Re: Notice of Planned Change – East Ash Pond Excavation Stormwater Management Phasing Plan  
July 2017 (Rev. 4)  
Virginia Pollutant Discharge Elimination System (VPDES) Permit No. VA0004138  
Dominion – Bremono Power Station

**RE: Dominion Bremo Power Station VPDES Permit No. VA0004138:**  
**Revised Notice of Planned Change**

## SUMMARY OF CHANGES EAST ASH POND EXCAVATION STORMWATER MANAGEMENT PHASING PLAN

## EAST ASH POND EXCAVATION STORMWATER MANAGEMENT PHASING PLAN

**FIGURE 2A**

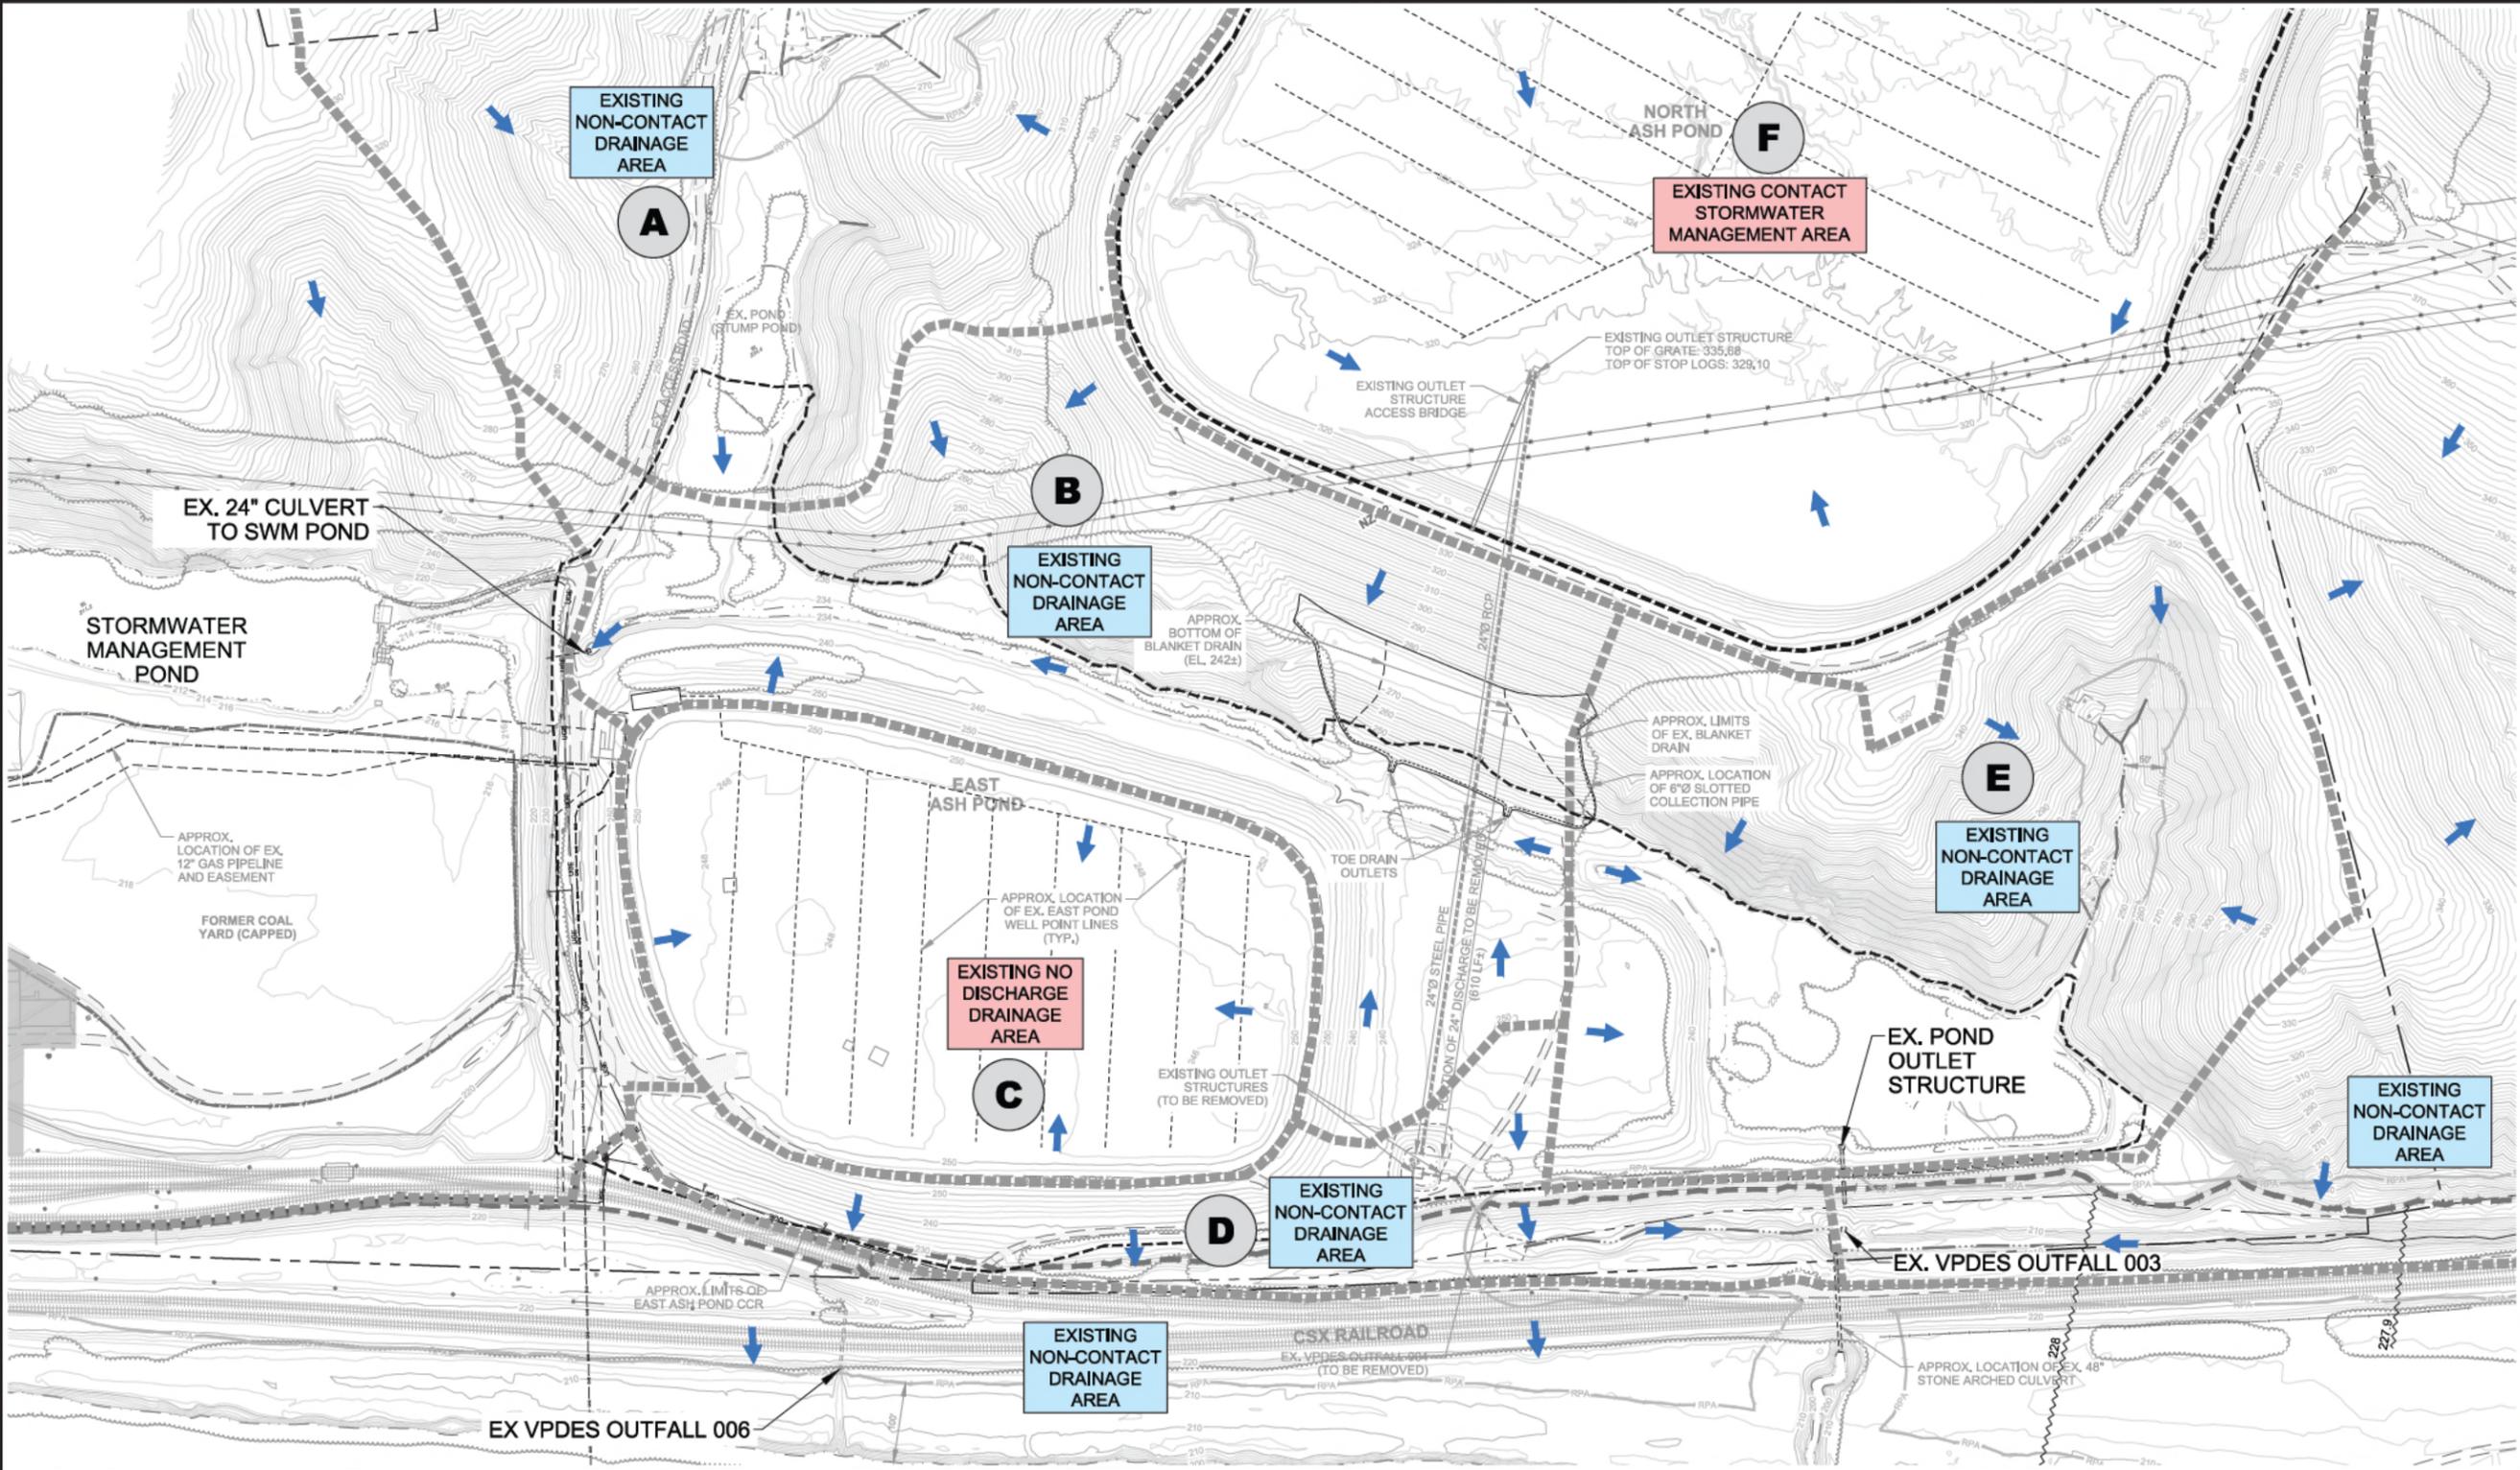
- Figure 2, Existing Conditions has been revised as Figure 2A and the label for the 24" culvert was revised to only reflect that the pipe exists (i.e., reference to its future status removed).
- A figure for Interim Pond Grading, Figure 2B, was added to depict the concurrent interim grading of Phases 1 through 5.
- Note 7 on Figure 3 was revised to specify the 24" culvert will be removed prior to the completion of Phase 5.
- The revision block was updated on Figures that were changed.

**FIGURE 6**

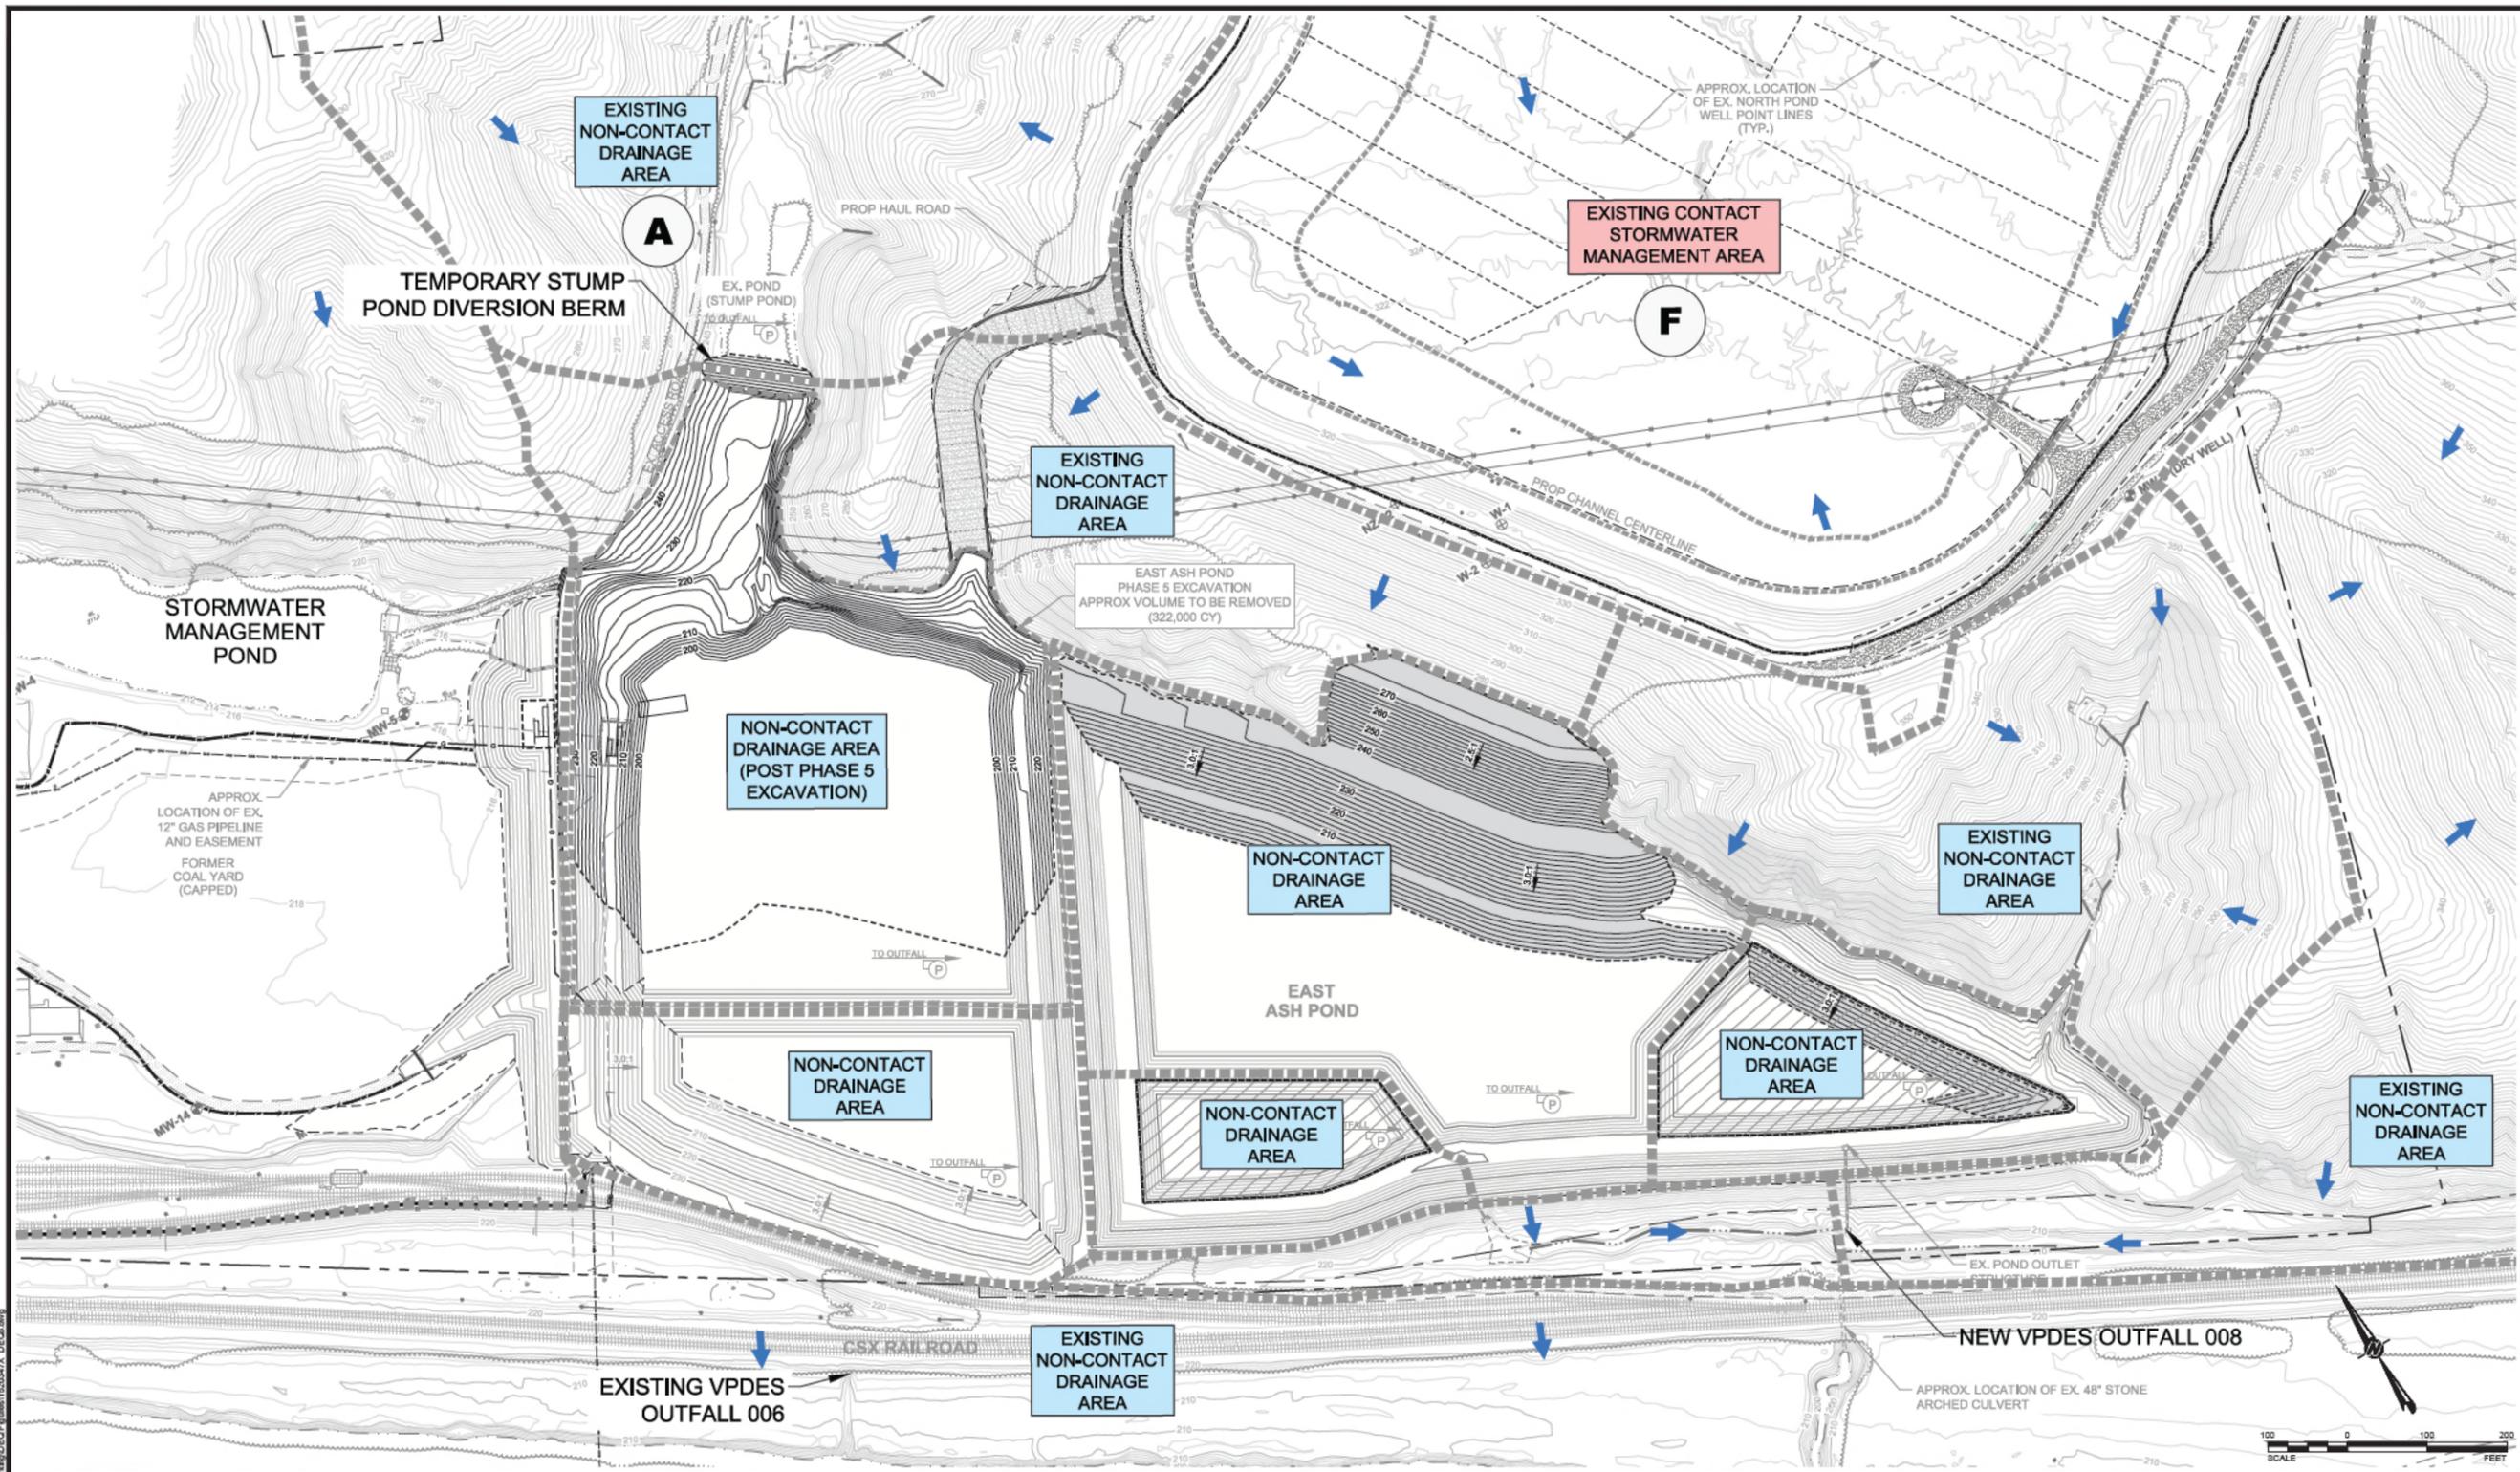
- A statement was added to Phase 3 that allows for Phase 3 to be excavated in conjunction with Phases 1 and 2.
- A statement was added to Phase 5 specifying the 24" culvert will be removed prior to the completion of Phase 5.
